MODEL BD-100-1A10 (CL-300)

REWORK – WING TANK – ADDITION OF SEALANT TO FACILITATE WATER DRAINAGE FROM WING FUEL TANKS AND PREVENT ERRATIC FUEL INDICATIONS

SERVICE BULLETIN

**REWORK – WING TANK – ADDITION OF SEALANT TO FACILITATE
WATER DRAINAGE FROM WING FUEL TANKS AND
PREVENT ERRATIC FUEL INDICATIONS**

K1000070228 – Kit – Fuel Tank Thermal Sealant Rework BL 0.00
(Sheet 1 of 3, Rev. A)

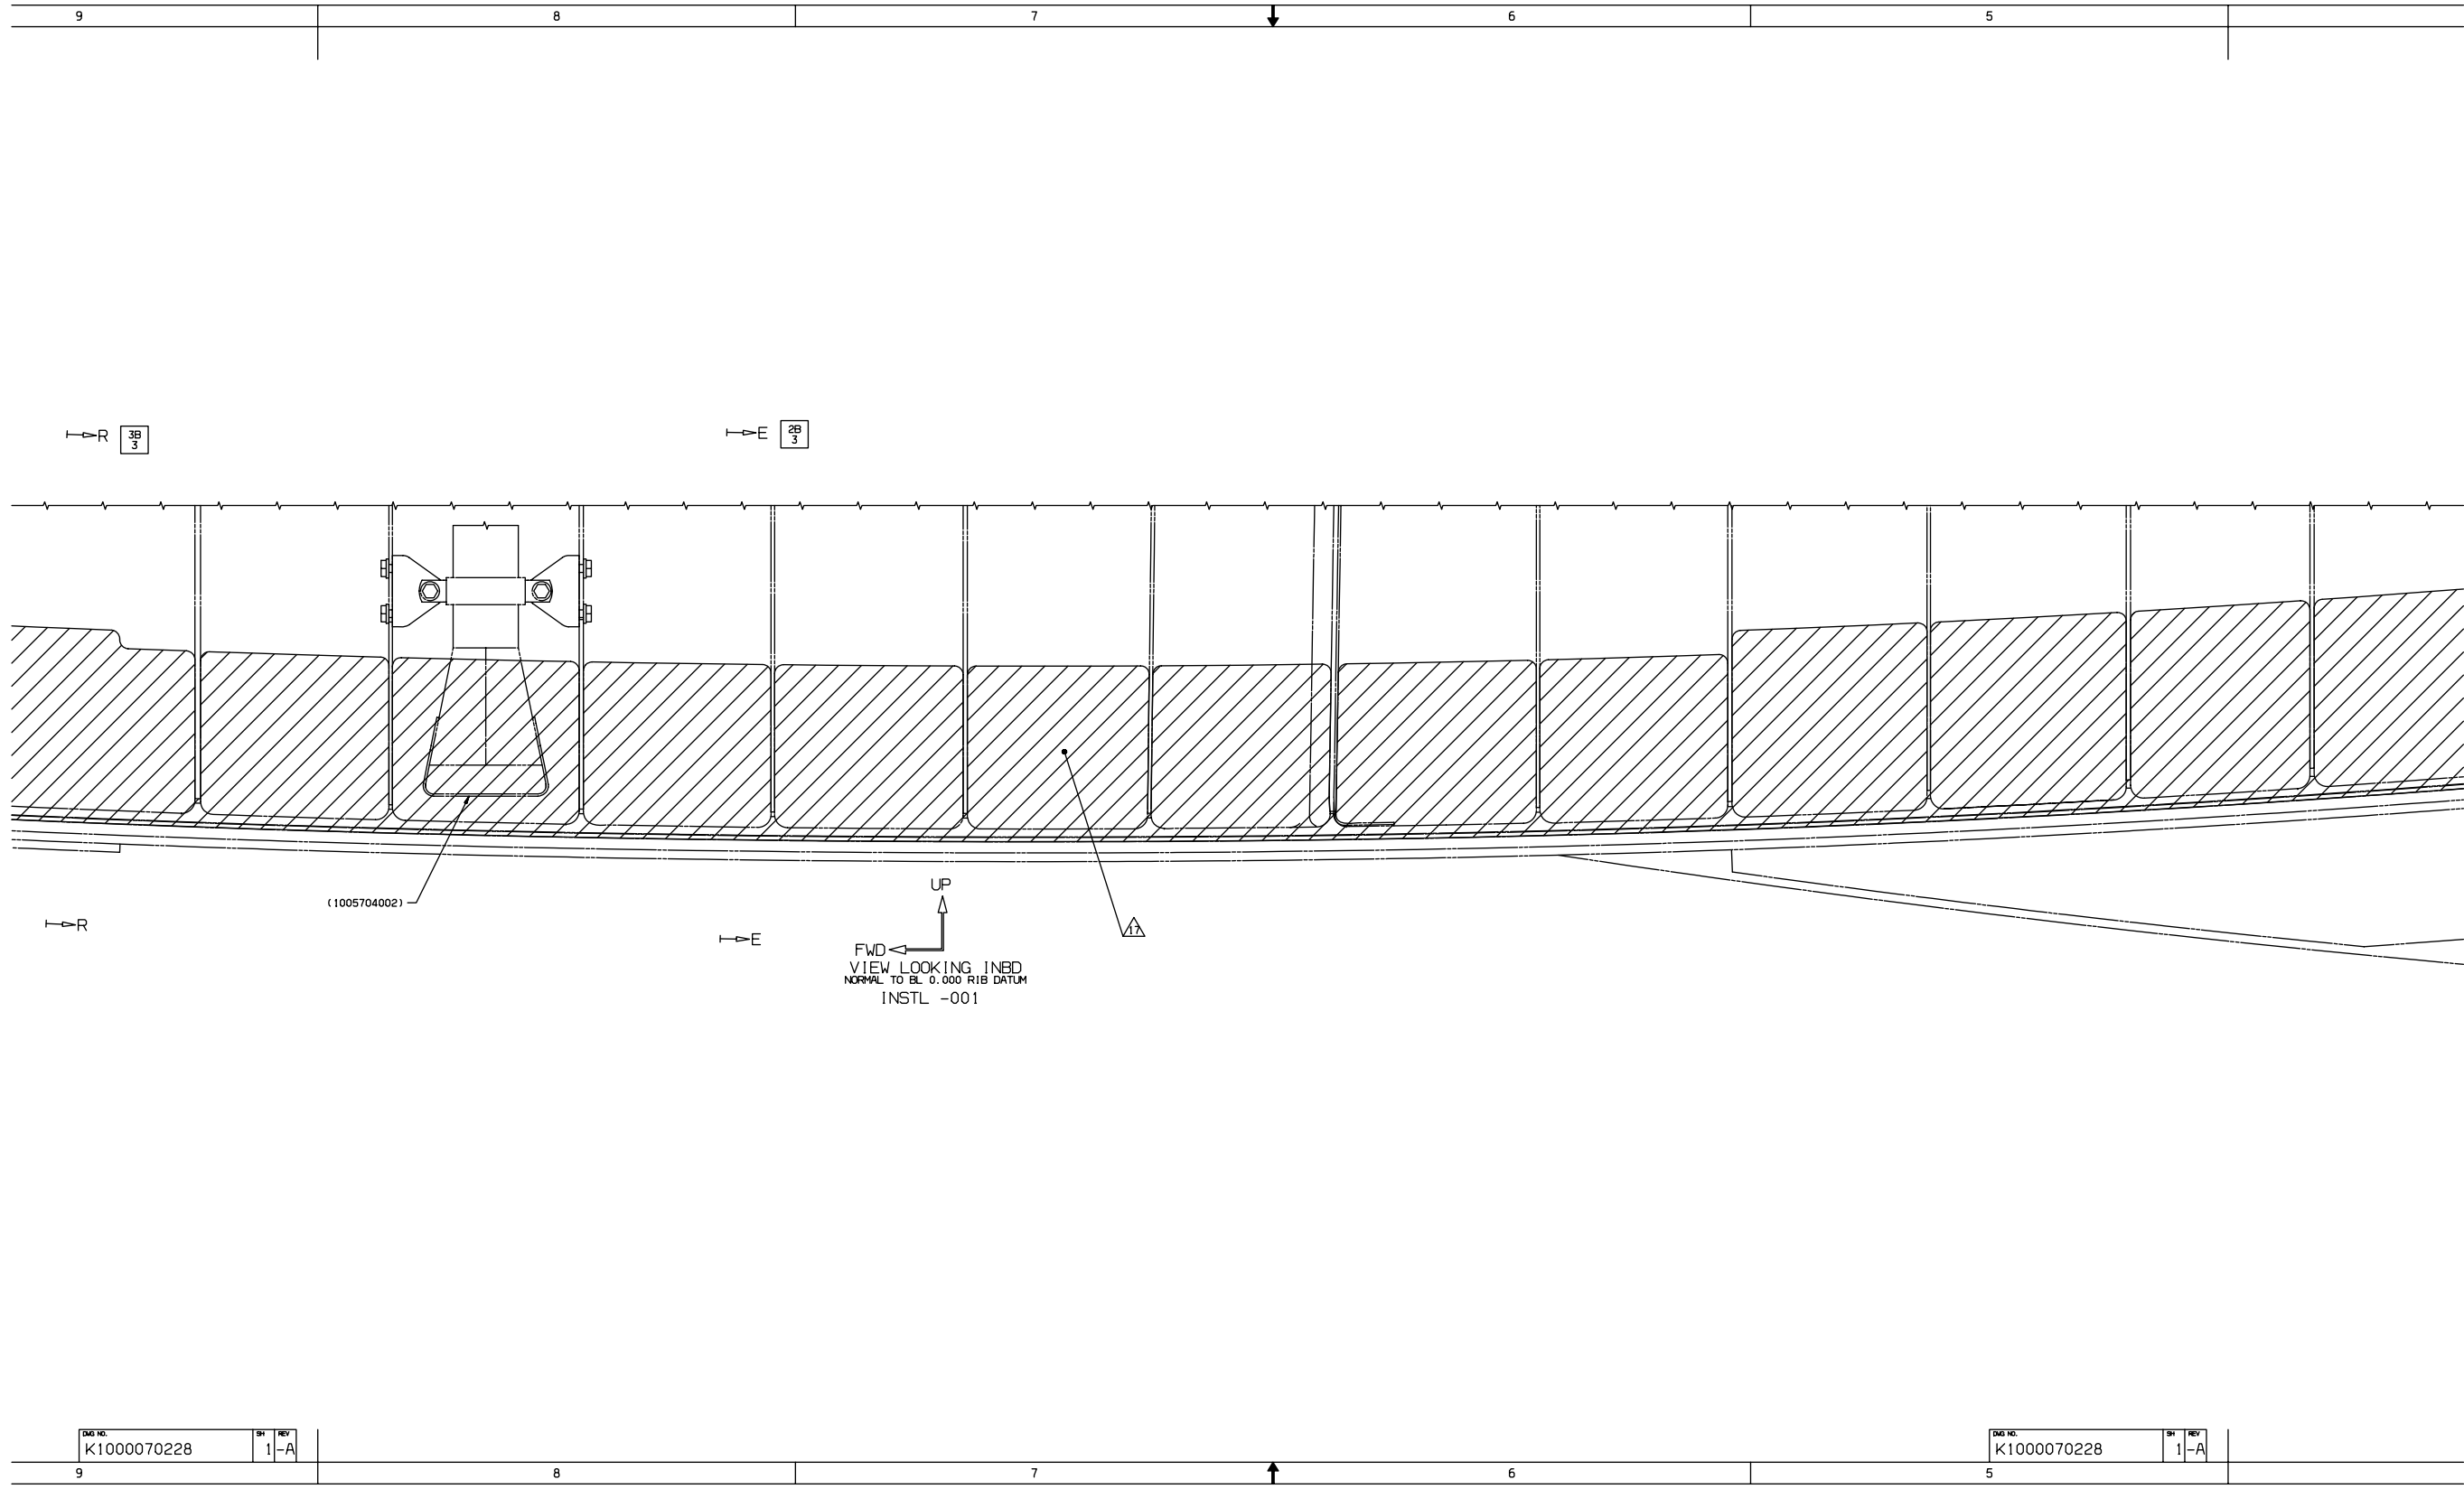
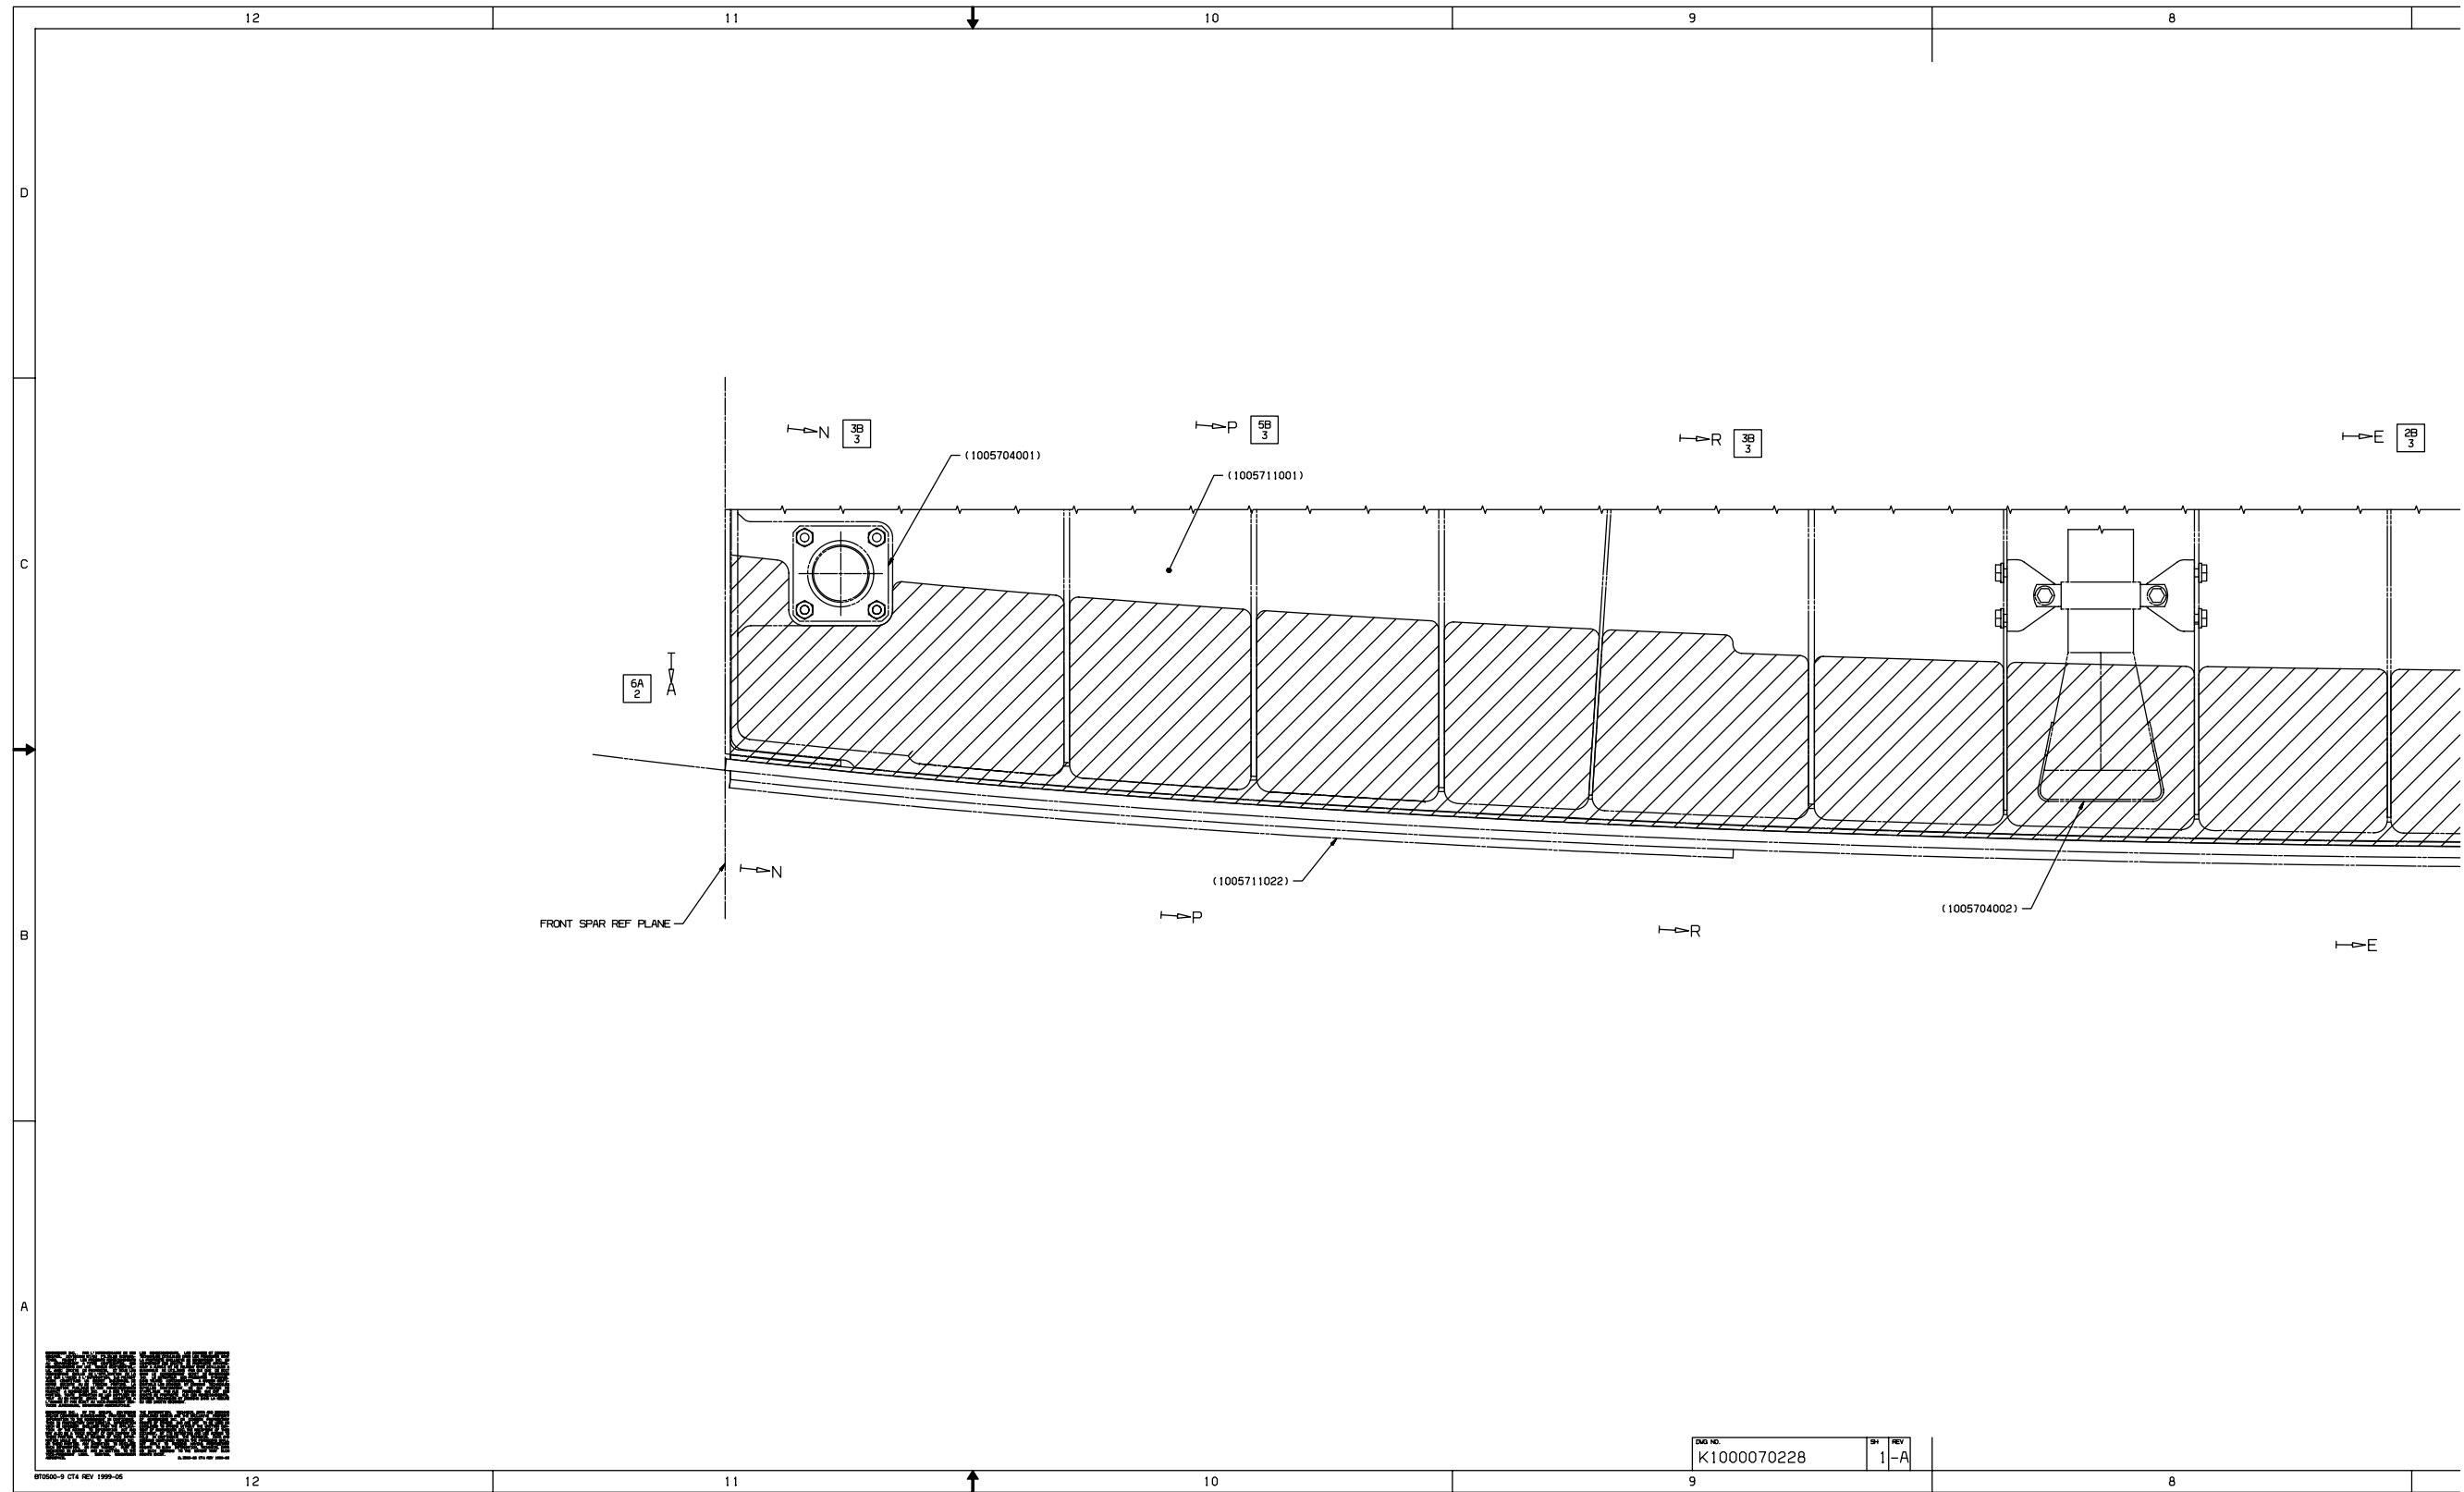
- (1) Using a non-metallic tool, remove the sealant to provide water drainage paths in all areas identified as flag note 14. Refer to Kit Drawing K1000070228; view A-A, sections E-E and R-R.
NOTE: The use of paint remover to soften sealant is not permitted.
- (2) Using a non-metallic tool, remove sealant in areas identified as flag note 18 as necessary to create a water drainage path. Refer to Kit Drawing K1000070228; flag note 14, 18 and view A-A.
- (3) Prepare areas indicated by flag note 13 of Kit Drawing K1000070228, view A-A, sections L-L, N-N, and P-P for thermal insulation sealant application as follows:
 - (a) Using a Scotch-brite, sand the exposed surface of the cured sealant.
 - (b) Vacuum and clean the area to be sealed. Refer to TASK 51-25-00-110-801.
